# CITY OF ALBUQUERQUE

**Re: McDonald's at Candelaria / Eubank, 9515 Candelaria,  
Traffic Circulation Layout  
No Engineer's Stamp provided (G20-D031)**

**Re: McDonalds, 9515 Candelaria NE**  
**Grading and Drainage Plan**  
**Engineer's Stamp dated 5/3/11 (G20/D031)**

## Narrative of City Comments

**POST DEVELOPED DRAINAGE PLAN**  
 L/C NUMBER: 030-0004

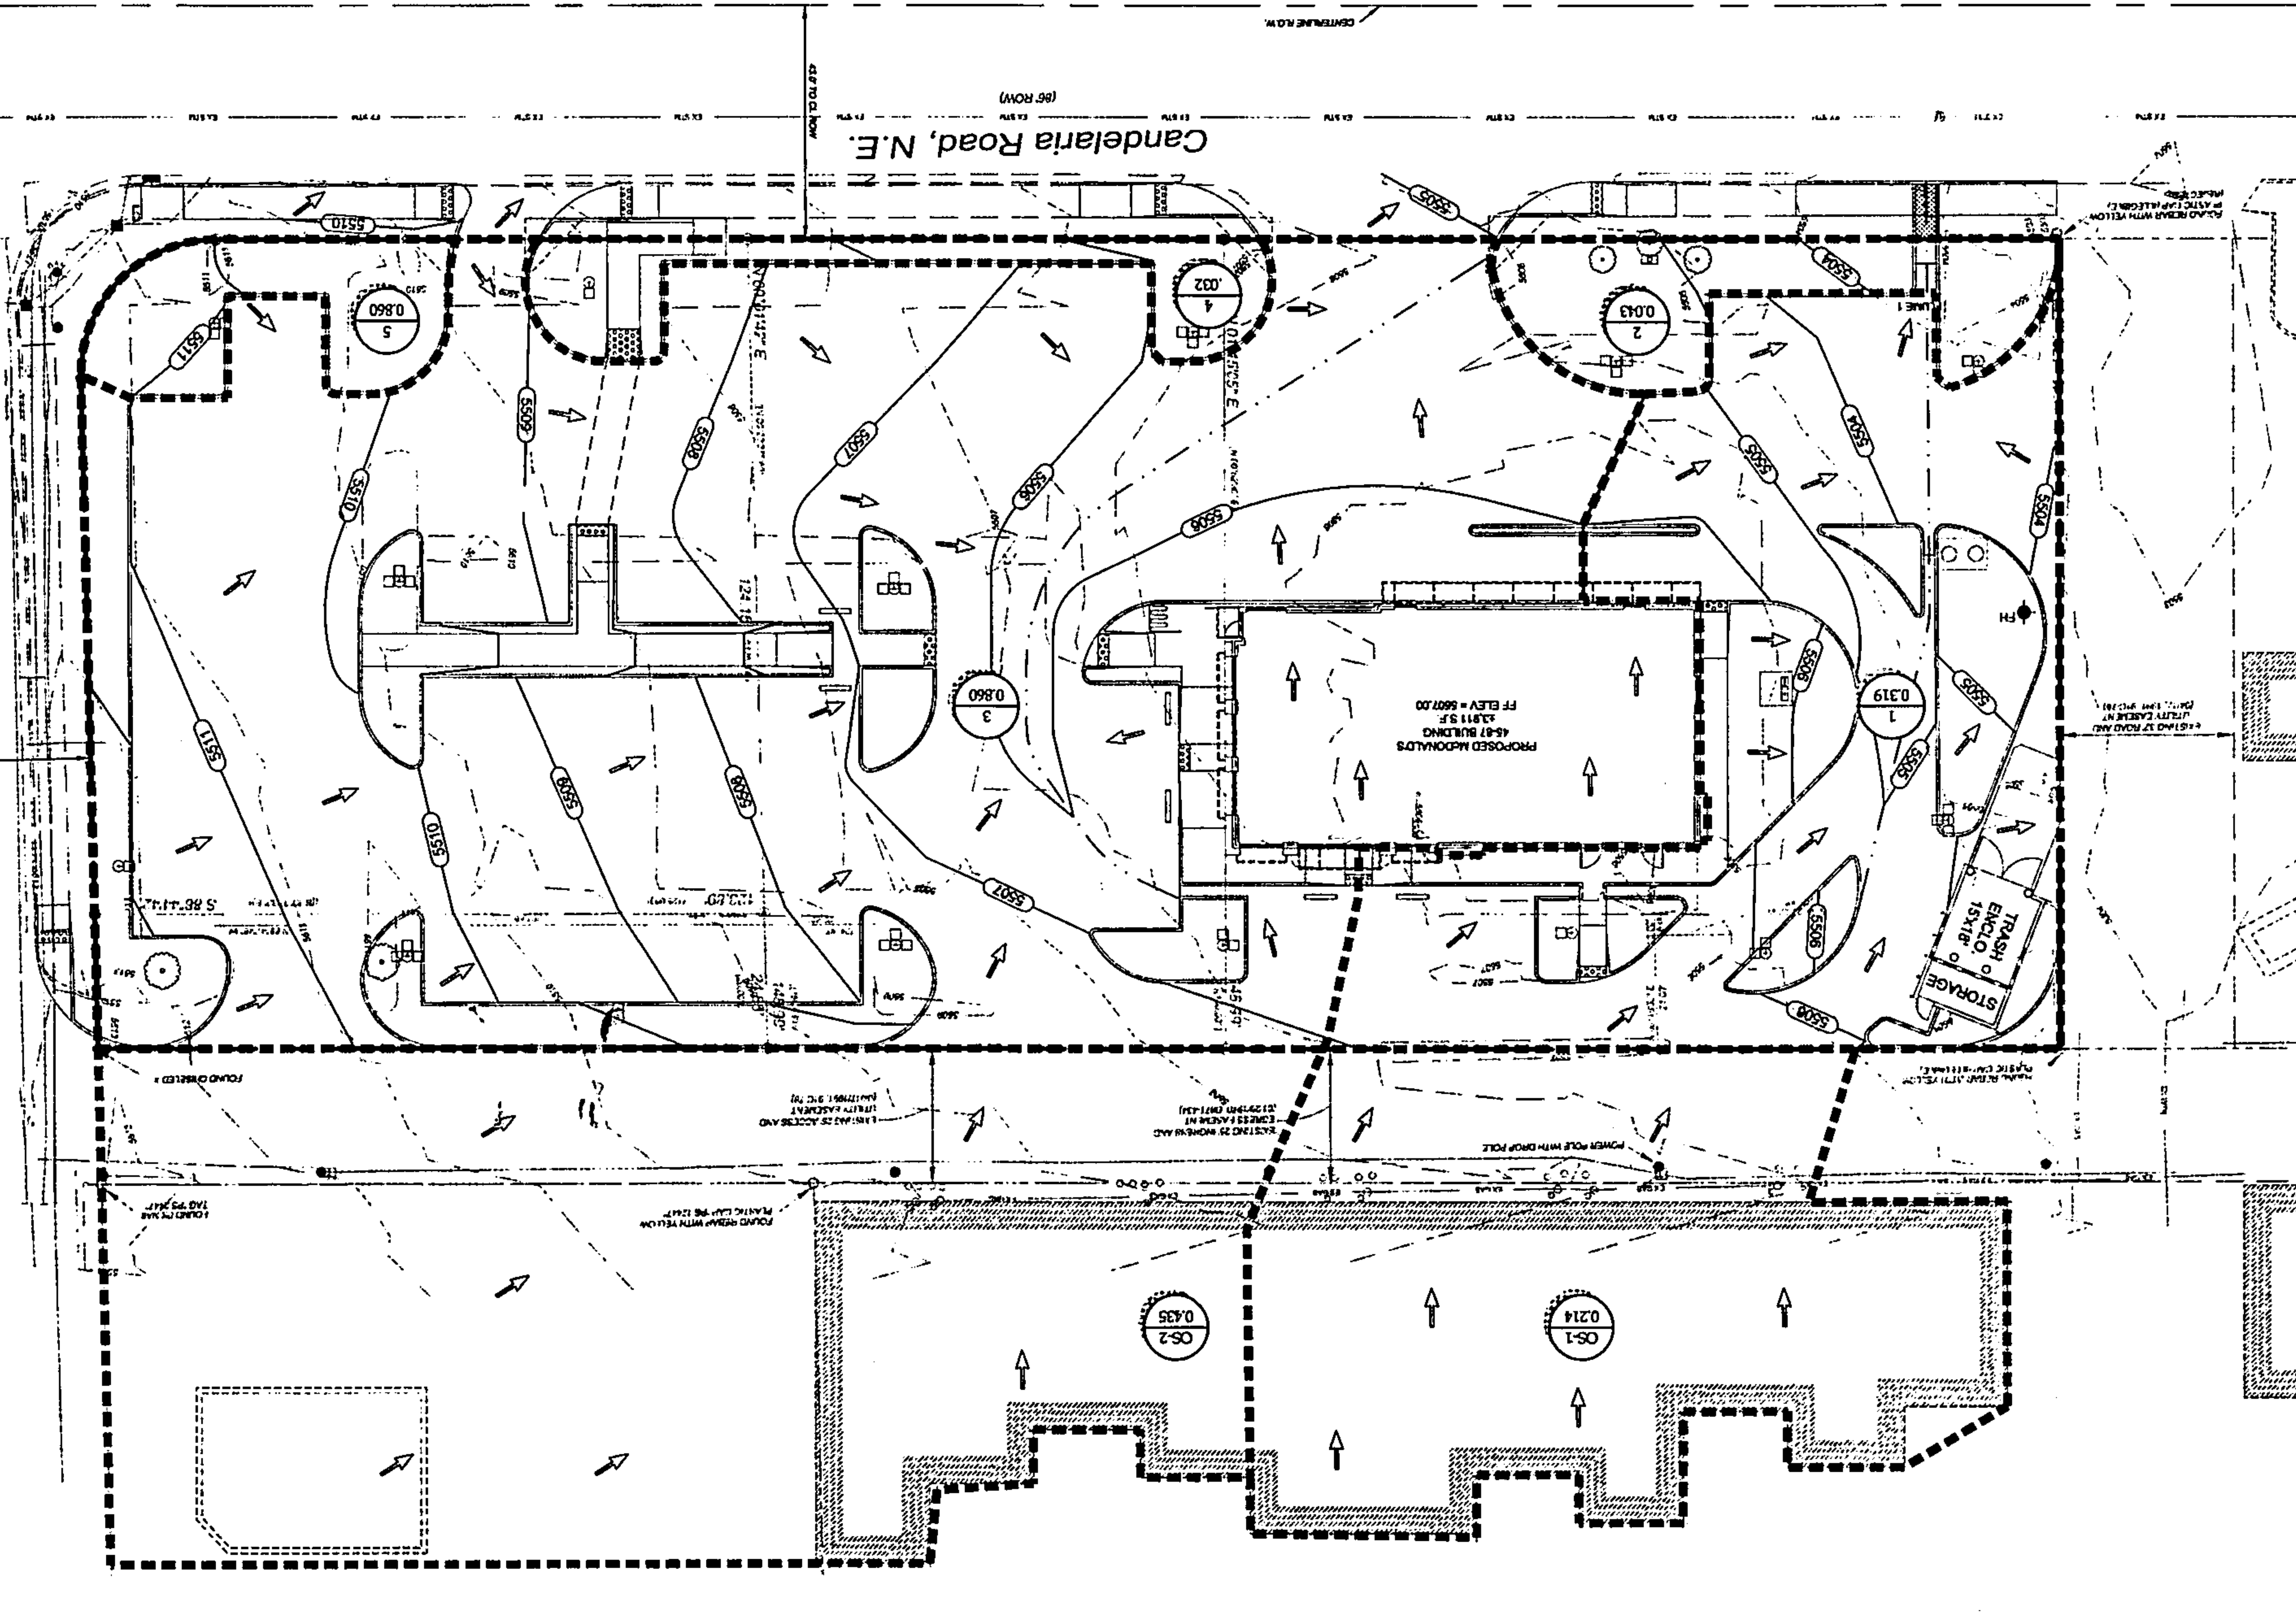
- Runoff from the flume needs to be discharged to the ROW via a sidewalk culvert (COA STD DWG 2236, plate extends to property line). ?

SIDEWALK CULVERT ADDED TO SITE PLAN SHEET C4.0 AND POST-DEVELOPED DRAINAGE PLAN SHEET C8.1
